Addendum 01

PROJECT: Zane Grey Intermediate School MVHC Clinic Renovation
968 Pine Street
Zanesville, Ohio 43701

PROJECT #: 25006.02

This addendum form is a part of the Contract Documents and modifies the Bidding Documents titled "Construction Documents," dated June 17, 2025, with amendments and additions noted below.

G-1 - TEMPERED GLAZING

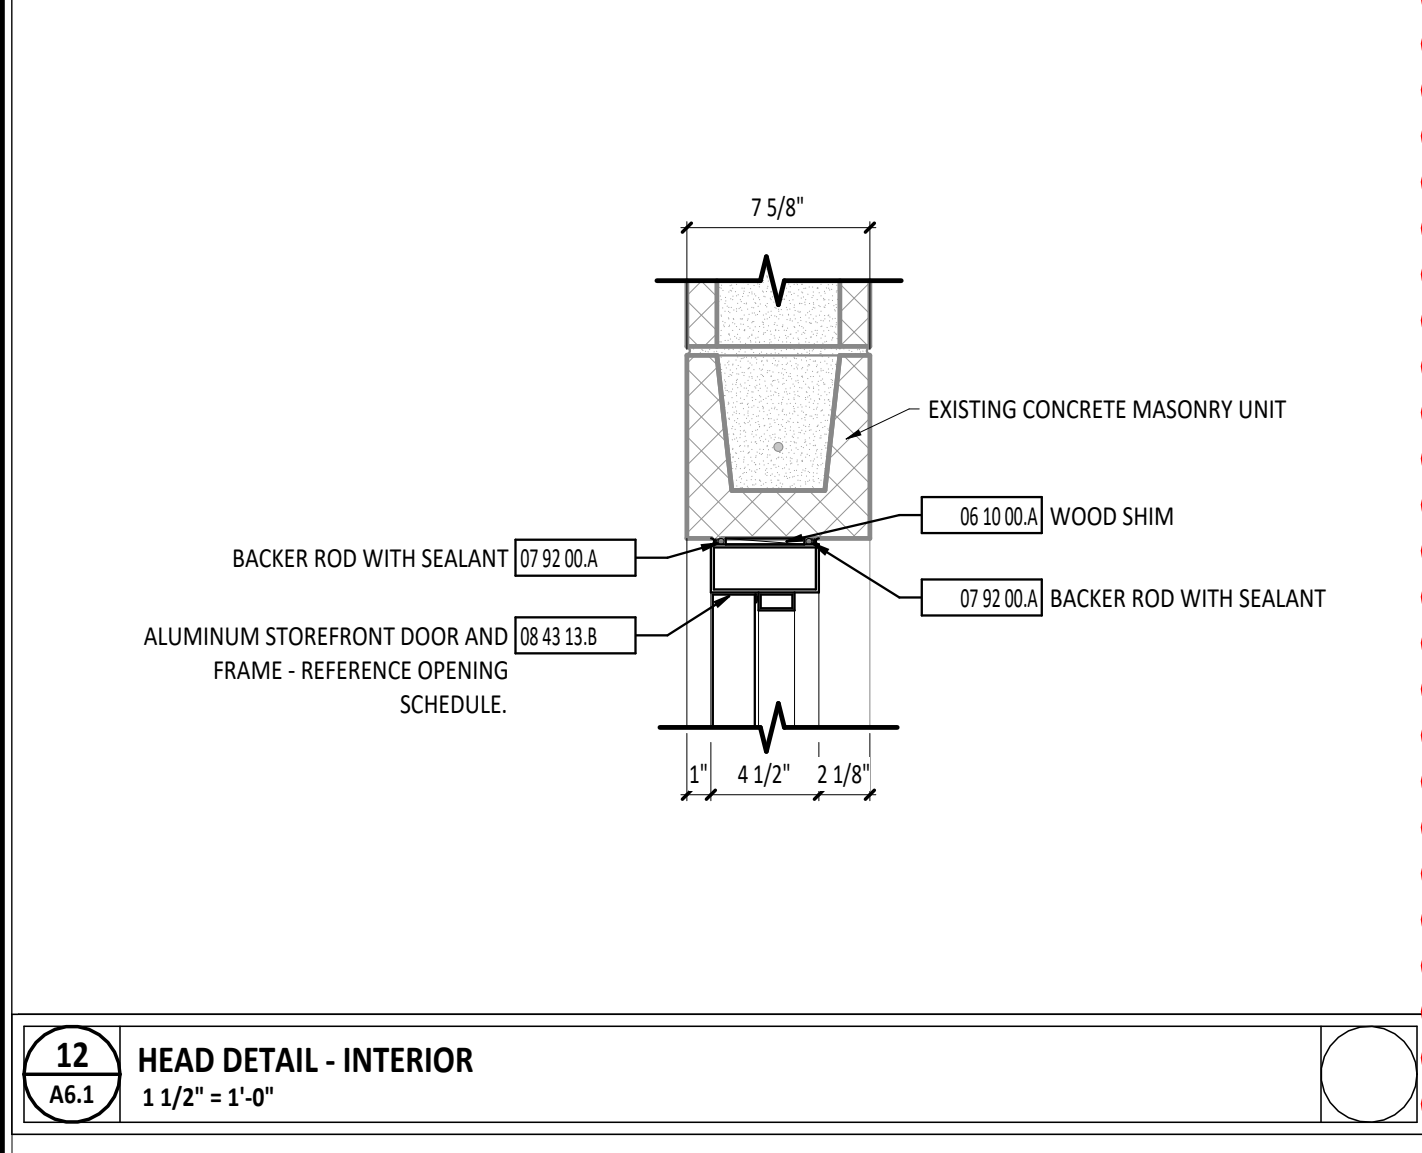
1. Drawing Sheet A6.1 Door Schedule & Door Details:
 - a. Add hardware sets to door schedule.
 - b. Revise detail 13/A6.1 to include structural steel lintel and plate.

SHEET NUMBER:
MD1.1

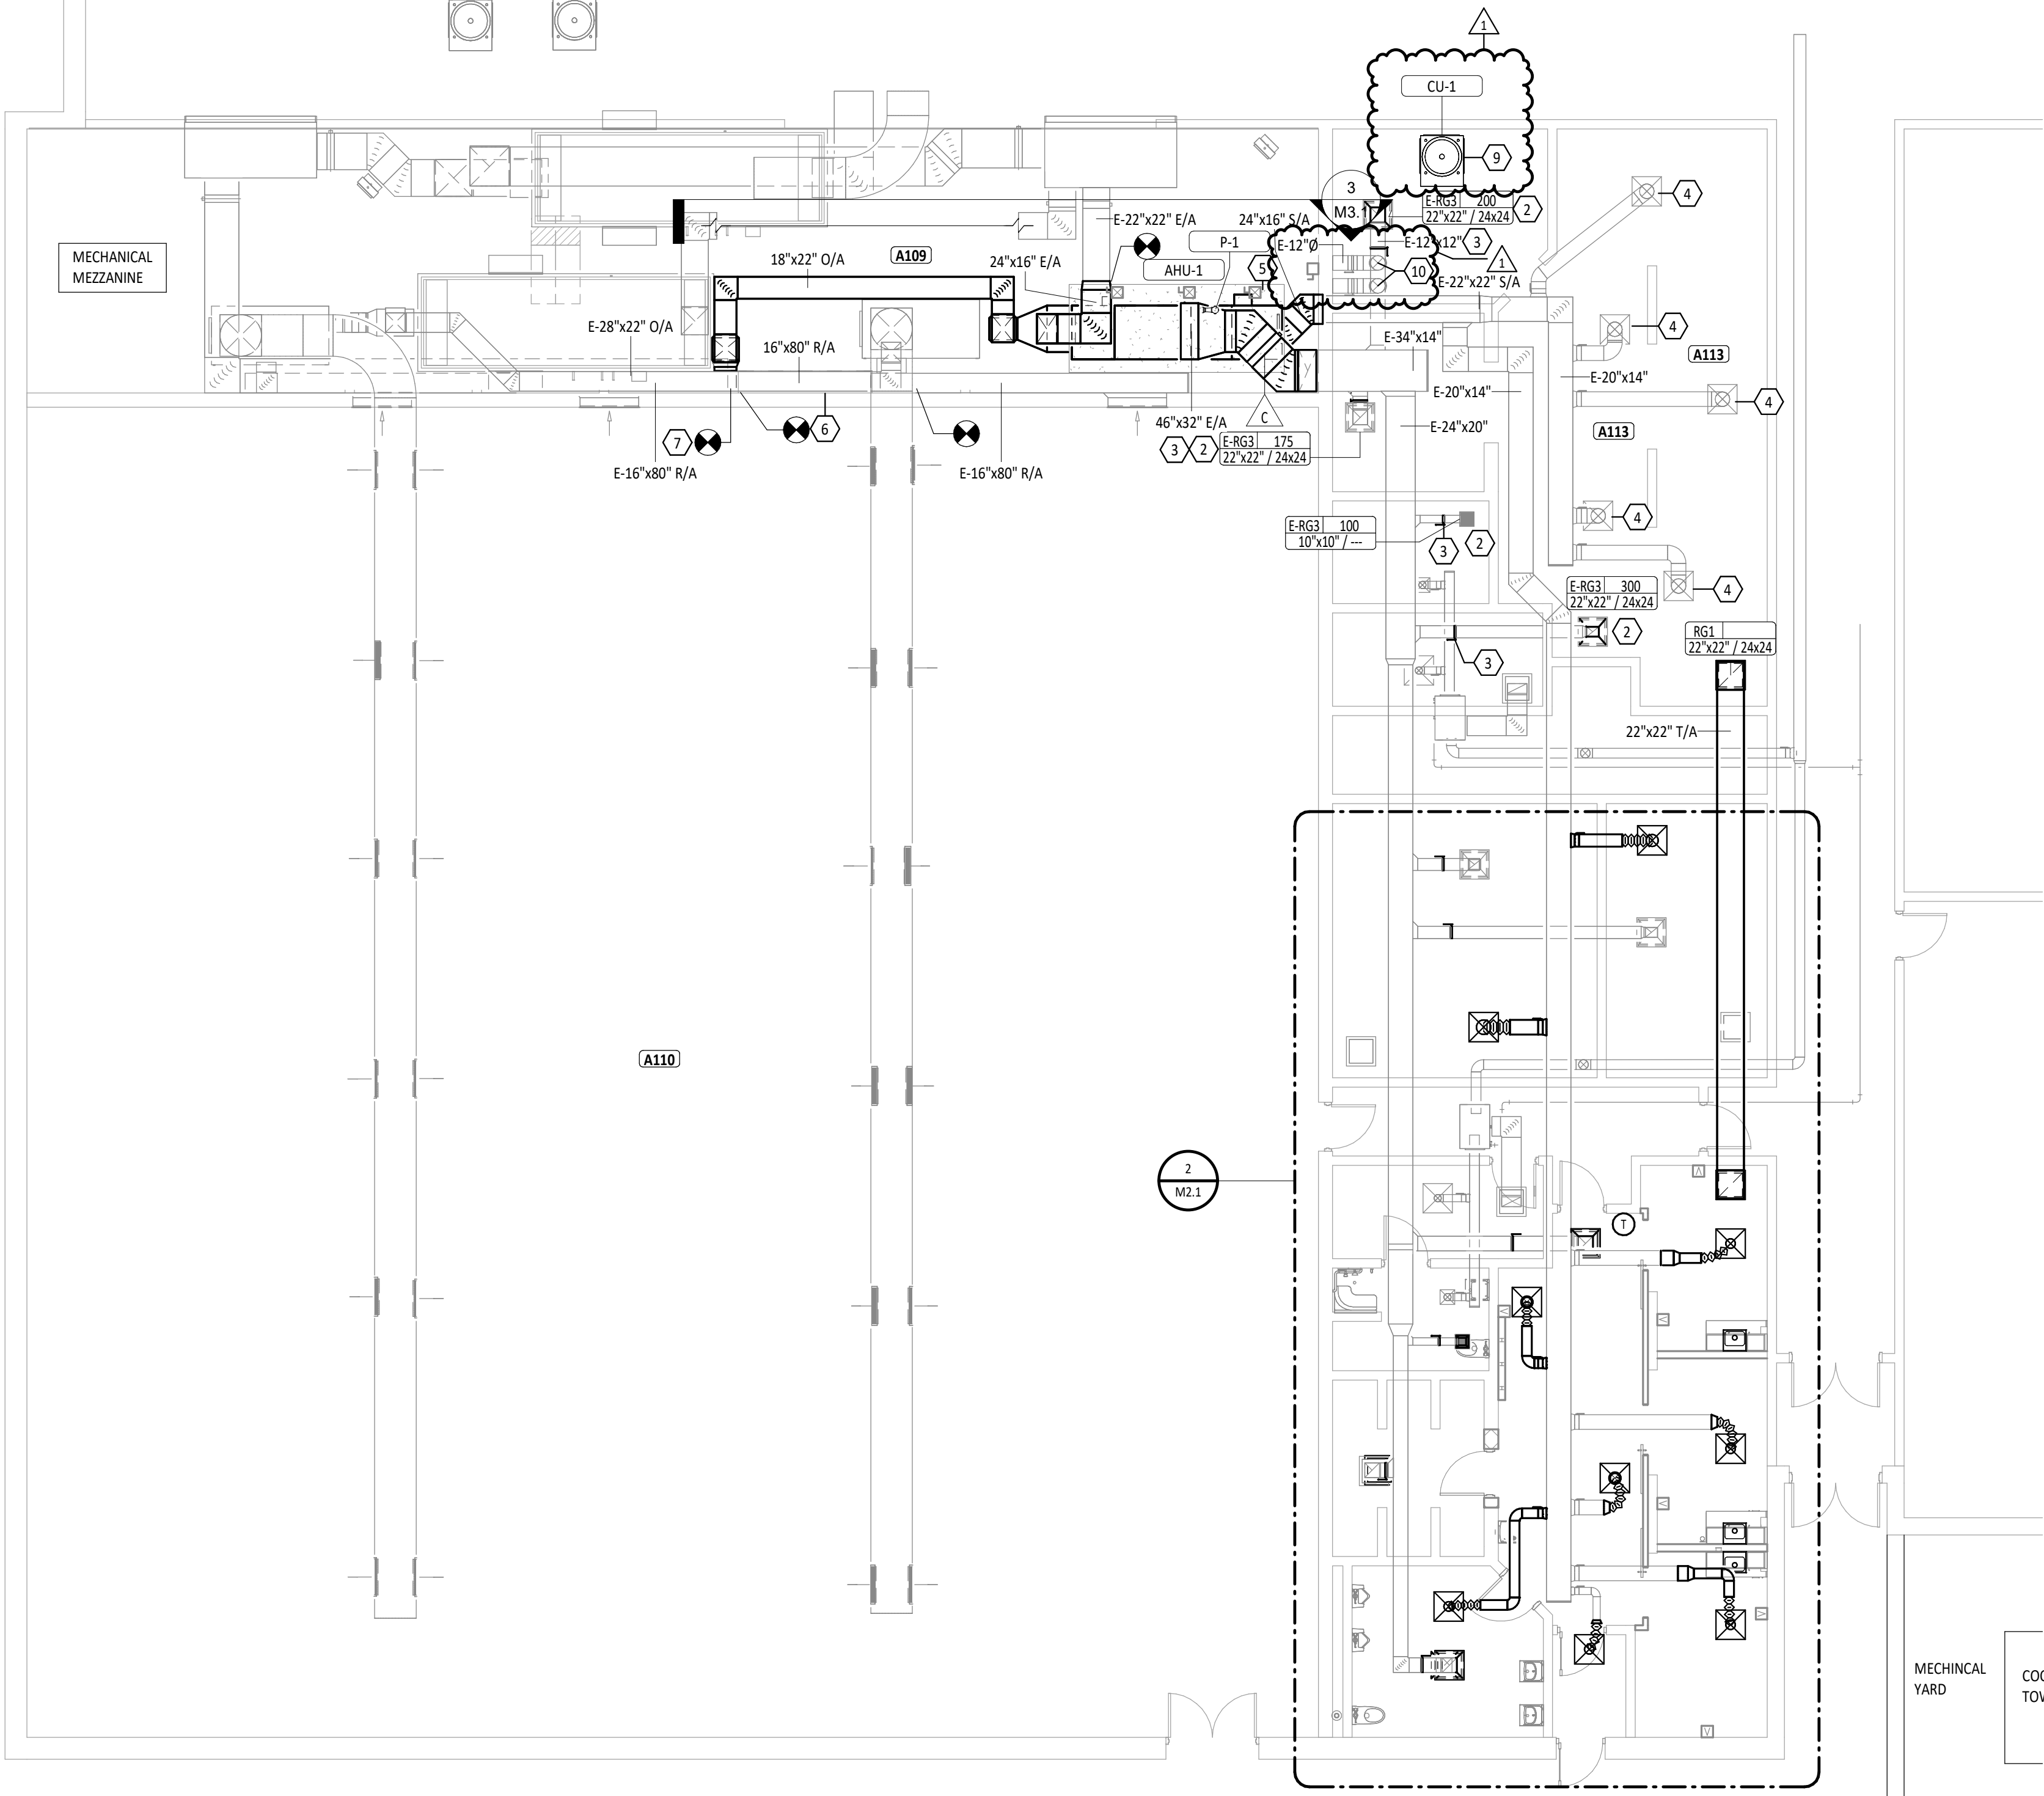
2. Drawing MD1.1 Mechanical Demolition Plan – Unit A:
 - a. Altered the amount of ductwork removed from the existing locker room
3. Drawing Sheet M2.1 First Floor Mechanical Plan – Unit A:

1 MECHANICAL PLAN - UNIT A
1/8" = 1'-0"

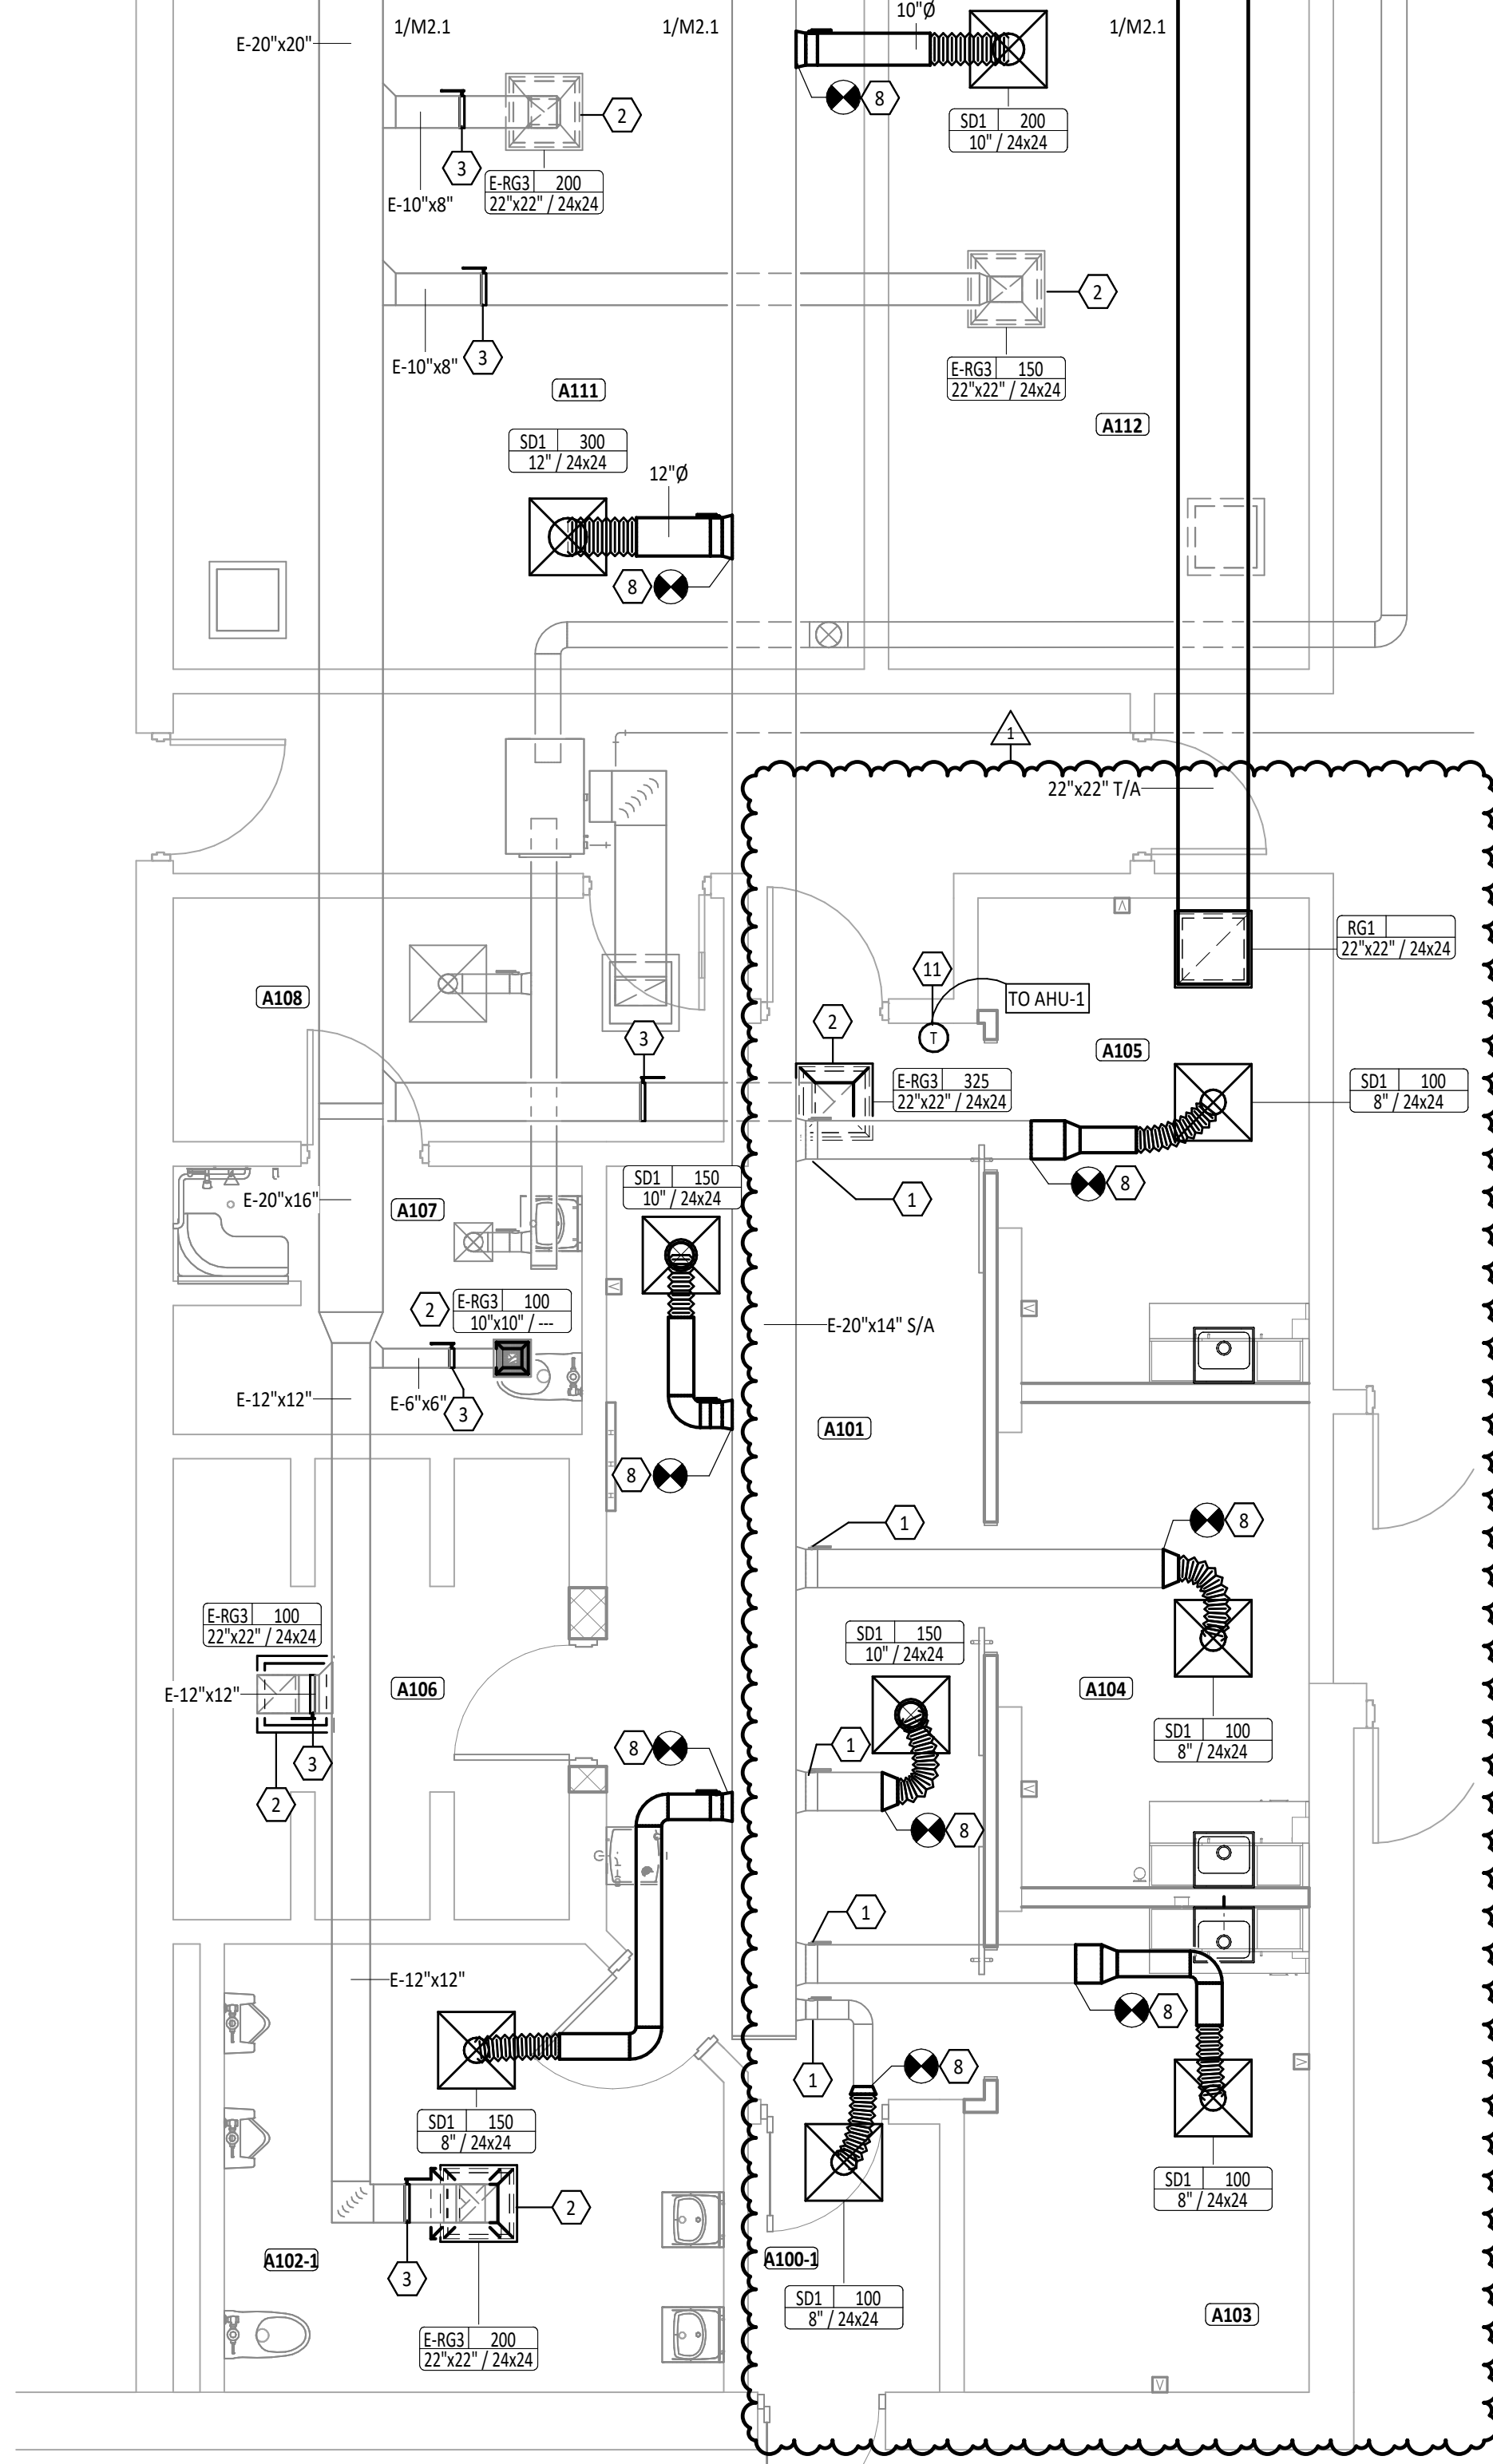
- a. Updated equipment schedules
 - b. Changed condensing unit from 2 units to 1 unit
 - c. Additional details provided via keynotes
4. Drawing Sheet M3.1 Mechanical Piping Plan & Details
